**Subject: June 2012 Inspection Report
Cameco Resources, Permits 603 & 633**

JUNE 2012 INSPECTION REPORT

PERMITS 603 & 633

COMPANY:	Cameco Resources
LOCATION:	North of Glenrock, Converse County (Smith-Highland Ranch Uranium Project)
DATE OF INSPECTION:	June 14, 2012
DATE OF REPORT :	July 12, 2012
INSPECTORS:	Pam Rothwell, Permit Coordinator
CO. STAFF PRESENT:	Ken Garoutte, Cameco SHEQ Manager Dave Moody, Cameco, Wellfield Operations Manager Craig Hiser, Wellfield Development Supervisor

Figure 7 View of water supply wells and hose near the water supply pond

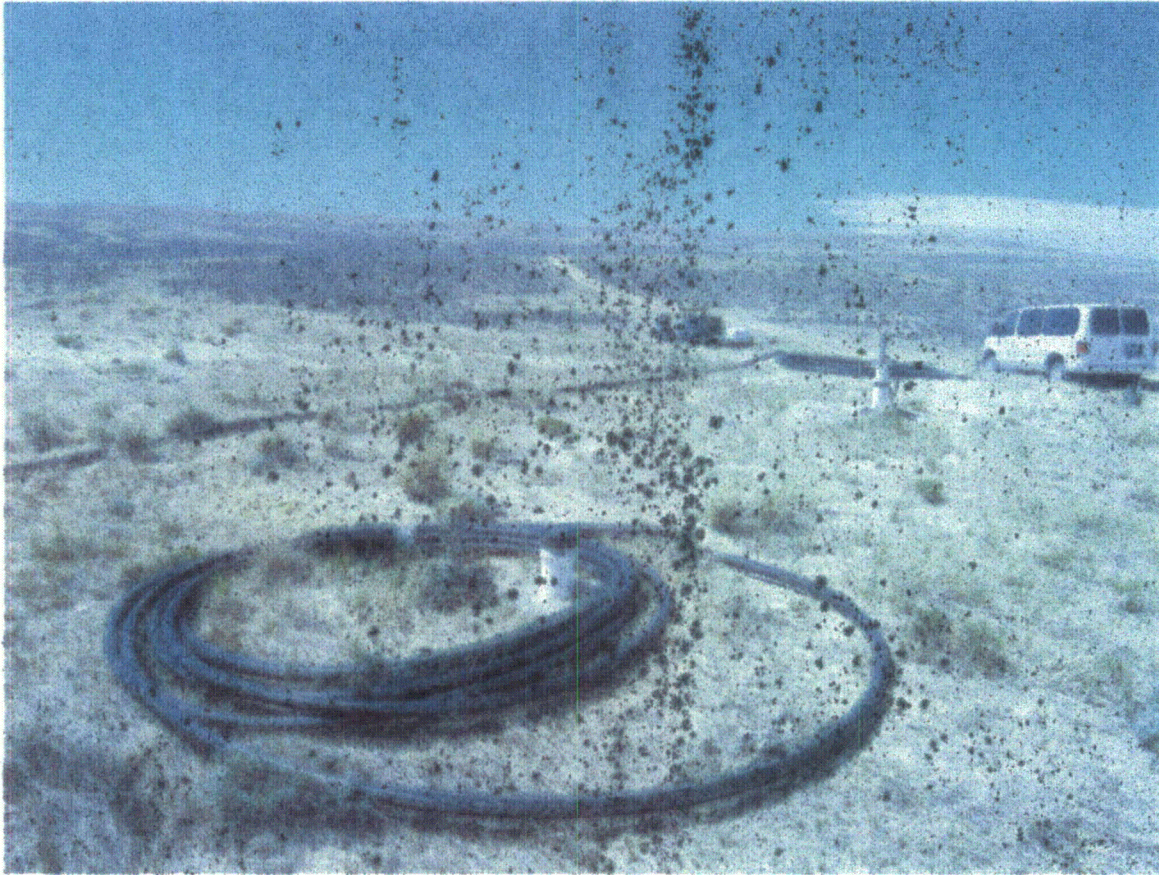
During observation of the water supply pond (Figure 7) it was discovered that there were additional wells installed to supply the pond. Those wells were approved by the State Engineer's Office and are permitted by the landowner (Figure 8).

- 4 A Notice of Violation, Docket No. 4988-12 was issued for disturbance outside the permit boundary and for unpermitted (LQD) use of water in the mining operations (water supply pond and wells). The violation was identified during the May 2012 inspection. Further inspection of the area was conducted to determine whether any of the wellfield unit injection or production wells were located outside the permit boundary. CR agreed to submit a professional survey of the boundary and wells near the boundary on a map. LQD also discovered additional wells were installed to supply the water supply pond. The map was provided to LQD on June 26, 2012. Cameco's practice has been to rely on the landowner for the appropriate permits for the water supplies used in the operation. The source, quality and quantity requirements of the Wyoming Environmental Quality Act have not been addressed in the permit. The additional wells found during the inspection, although not identified in the Notice of Violation will be addressed in the Settlement Agreement.
